ADDENDUM NO. 1

**COCHECO WELL NO. 1
WATER TREATMENT FACILITY**

AUGUST 20, 2009

**PREPARED BY:
WRIGHT-PIERCE ENGINEERS
230 Commerce Way, Suite 302
Portsmouth, NH 03801
Tel. 603-430-3728
Fax 603-430-4083**

TYPICAL CMU WALL OPENING GREATER THAN 3'-6"

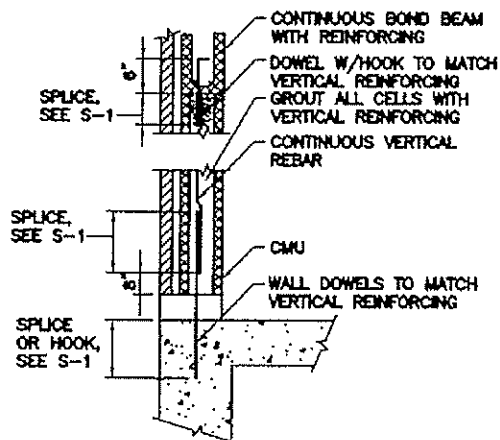
20. Drawing S-6, **REPLACE** the two details "Typical CMU Wall Opening Greater than 3'-6" and "CMU Wall Reinforcing Schedule" with respective details on the attached sketch SK-1.

NOTE: DETAIL TYPICAL AT ALL OPENINGS EXCEPT AT INTERIOR BEARING WALL. REFER TO CMU WALL REINFORCING SCHEDULE.

SK-1

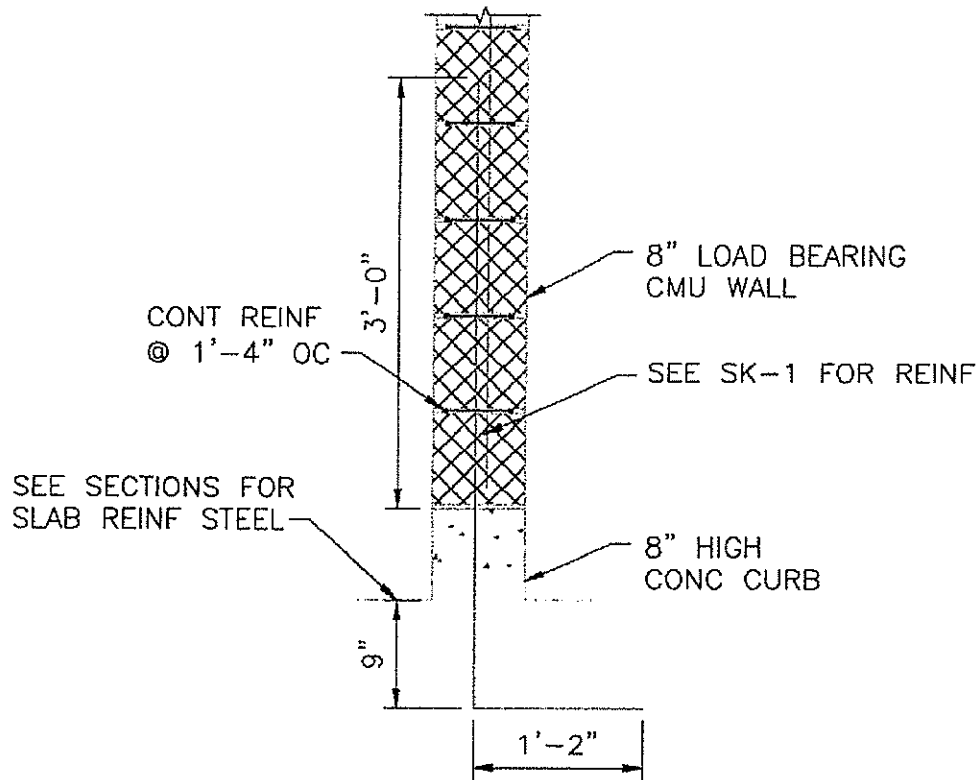
18. Drawing S-3, **REPLACE** Detail D with the attached sketch SK-2.

SECTION  **3**
SCALE: 1/4" = 1'-0"  A-2 A-3, S-4

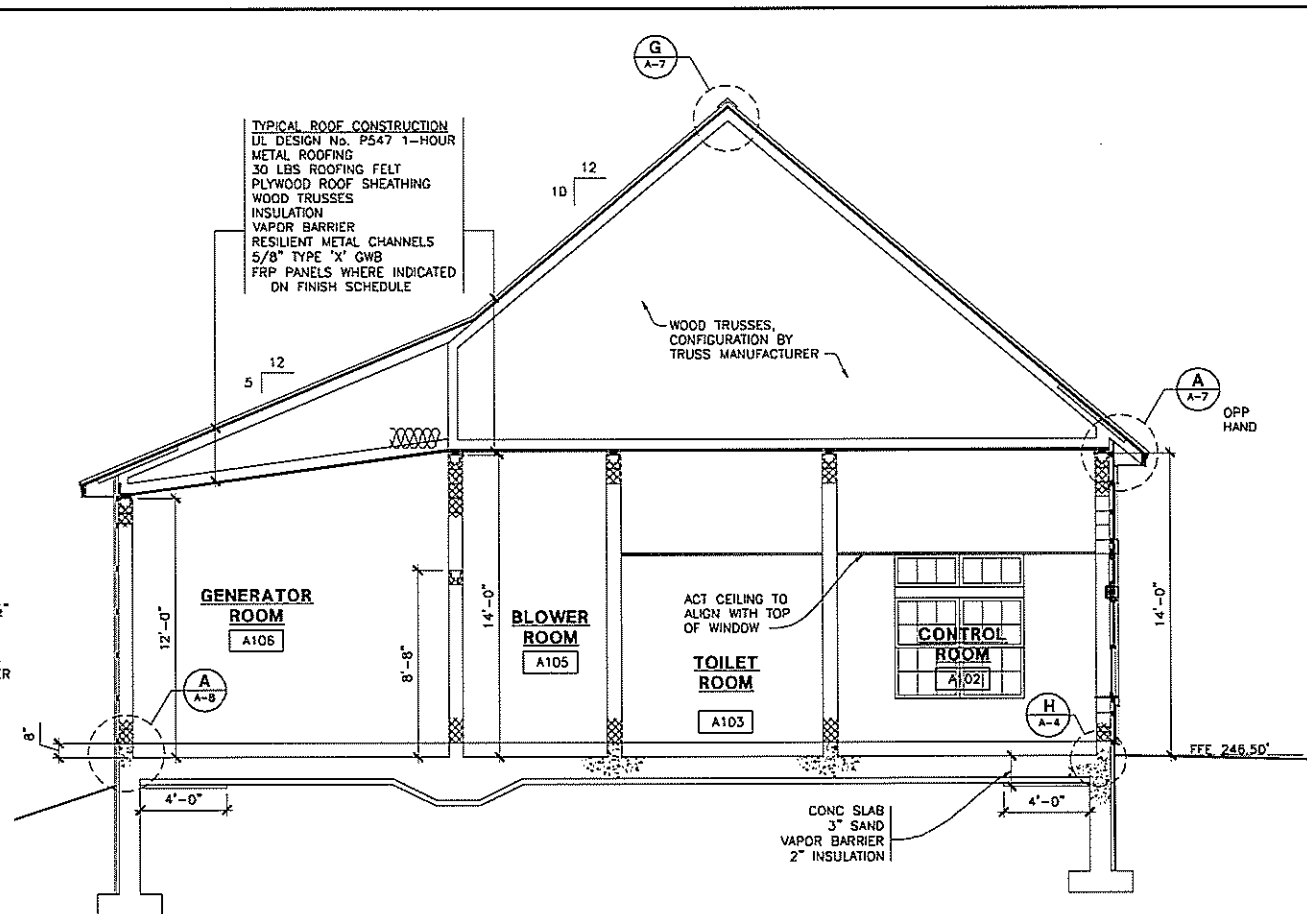
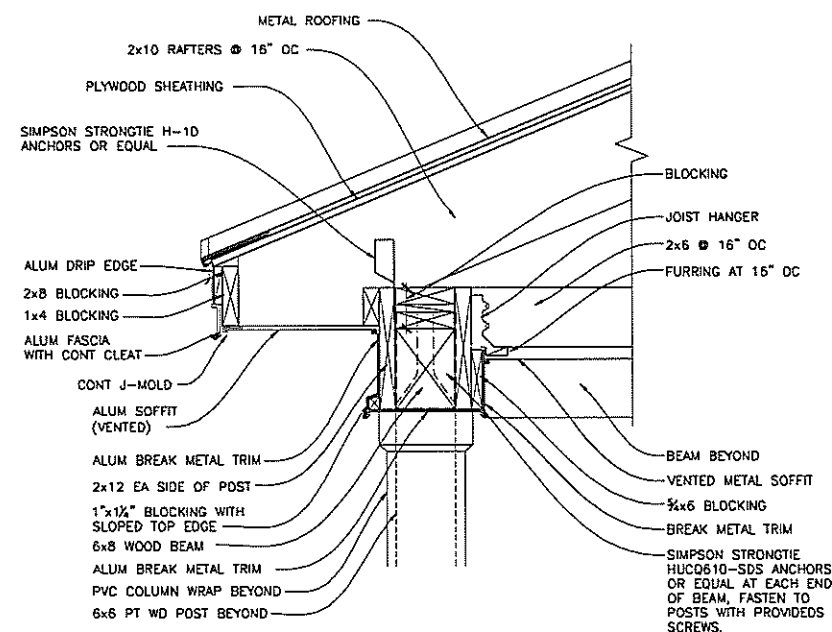
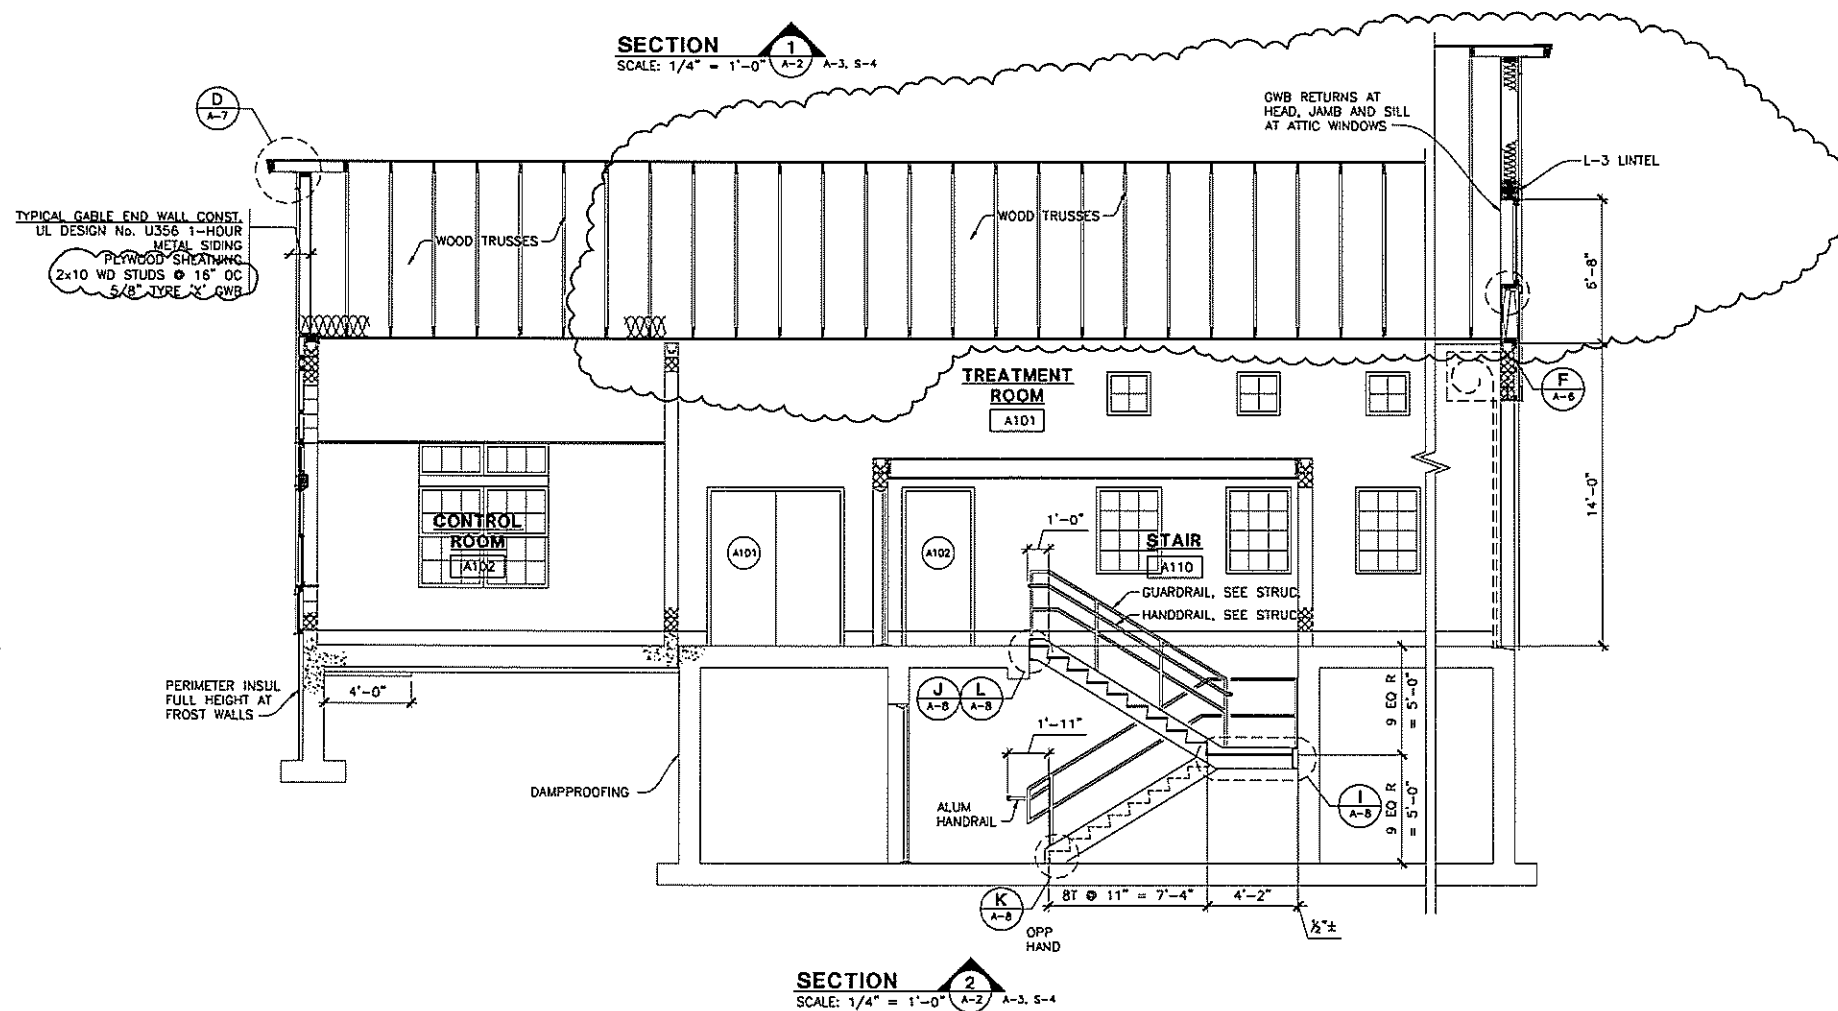
19. Drawing S-4, **REPLACE** sheet with attached revised drawing S-4REV.

21. Drawing S-7, **DELETE** "LIFT HOOK DETAIL" entirely. This detail is to be replaced with a lift hook detail as shown on the attached drawing S-4REV noted above.

- NOTES:**
1. TRUSS DESIGN LOADS:
TOP CHORD LIVE LOAD = 33 PSF
1/2 SLOPE = SOUTH SIDE = 33 PSF
1/2 SLOPE = NORTH SIDE = 53 PSF
1/2 SLOPE = 53 PSF
TOP CHORD DEAD LOAD = 11 PSF
BOTTOM CHORD LIVE LOAD = 20 PSF (OVER ENTIRE BOTTOM CHORD)
BOTTOM CHORD DEAD LOAD = 15 PSF
ADDITIONAL LOADS:
LIFTING HOOKS - ALL LIFTING HOOKS SHALL BE LABELED "1 TON CAPACITY". TRUSSES SHALL BE DESIGNED TO SUPPORT ONLY ONE LIFT HOOK AT A TIME. EACH TRUSS SHALL BE DESIGNED TO SUPPORT 1/2 OF THE LIFTING HOOK LOAD. CUPOLA - ADDITIONAL 750 LB OVER 4'-0" SQ AREA

2. HURRICANE ANCHOR SCHEDULE:
C1 - PINNED - USP RT16 OR USP RT16-2, OR EQUIVALENT
C2 - GABLE END BRACE - OBC BY SIMPSON STRONGTIE OR EQUIVALENT
ALL ANCHORS SHALL BE STAINLESS STEEL OR ZMAX G185 HDG.

3. REFER TO DRAWING S-1 FOR TRUSS BRACING AND NAILING. LAP ALL LATERAL BRACING 2 TRUSSES MINIMUM.
 4. FOR STRUCTURAL NOTES AND TYPICAL DETAILS, SEE DRAWINGS S-1, S-6 AND S-7.
